City of Tualatin

ARCHITECTURAL REVIEW FINDINGS AND DECISION

Case #: AR-15-07
Project: Thermal Modification Technologies Additional Building
Location: [19830 SW Teton Ave](#) (Tax Lot 2S1 23CC 01300)
Applicant: Steve Mason, Integrated Facility Services, LLC (503-345-0334) (Job No. 16)

SHEET CONTENT
DEVELOPMENT AREA
LANDSCAPING PLAN

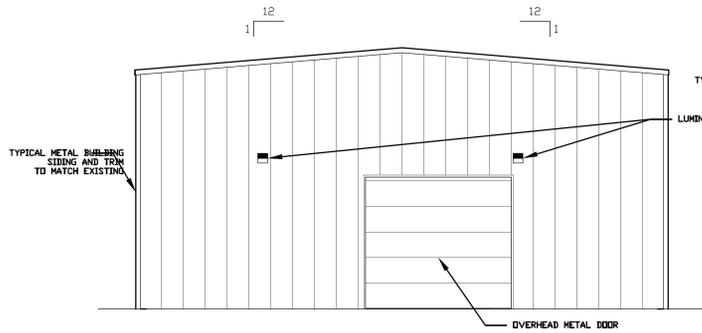
Because the site plans lack information about shrubbery within the proposed reconfigured landscaping, staff is unable to determine compliance and so is applying a condition.

Because the site plans lack information about groundcover within the proposed reconfigured landscaping, staff is unable to determine compliance and so is applying a condition.

Because the site plans lack illustration or notation of an existing or extended automatic irrigation system, staff is unable to determine compliance and so is applying a condition.

Because the site plans illustrate no 5-ft landscaped strip along the west side of the shed, excepting the loading door, that is visible from the parking area to the west, and indicates a 3-ft landscaped strip along the north side of the shed that is visible from parking area to north, the proposal fails to meet the requirement and so staff is applying a condition.

Because the site plans imply removal of four existing landscaped area trees near the north side of the proposed shed to accommodate the proposed requirement of the shed, it appears criterion (c) would apply and be met. However, because of the lack of clear information, staff is unable to confirm compliance with the requirement and so is applying a condition.

- The applicant shall revise the site plans to provide information about whether shrubs are proposed and if so their gallon size or gallon size range.

- The applicant shall revise the site plans to provide information about the groundcover(s) proposed and confirm exclusion of English ivy.

- The applicant shall revise the site plans to illustrate or note provision of automatic irrigation.

- The applicant shall revise the site plans to illustrate and note provision of 5-ft wide landscaped strips along the west side of the shed, excepting the loading door, and along the north side of the shed.

- The applicant shall revise the site plans to clarify if there is tree removal and if so provide text and graphic information about it.

SHEET CONTENT
ELEVATIONS

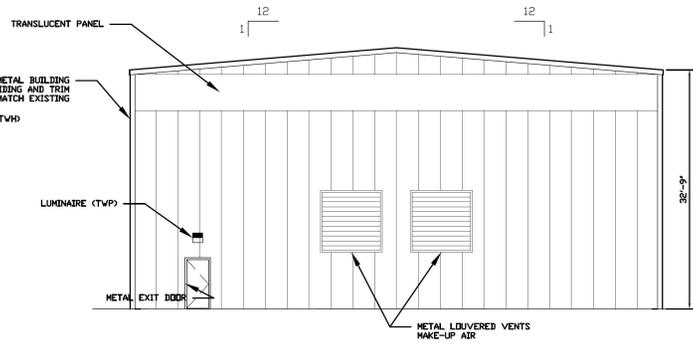
The elevations illustrate four wall-mounted exterior light fixtures on the shed, of which two are on the west façade facing SW Teton Avenue, one is on the south façade, and one is on the east façade facing towards adjacent undeveloped Lot 1700 consisting of wetlands and some undeveloped uplands.

Because the model is not full cut-off, the west lights face public right-of-way, and the east lights face wildlife habitat, they shine or create glare and so staff is applying a condition. Staff looks to the *Guidelines for Good Exterior Lighting Plans* (Attachment 104) to administer the exterior lighting standards, from which comes the diagram reproduced below. The applicant needs to instead provide fixtures that are full cut-off.

- The applicant shall revise the elevations sheet and provide a light fixture cut sheet or sheets to demonstrate that the proposed wall-mounted lights on the east and west elevations of the shed are full cut-off fixtures. The *Guidelines for Good Exterior Lighting Plans* (Attachment 104) is available as an implementation aid.
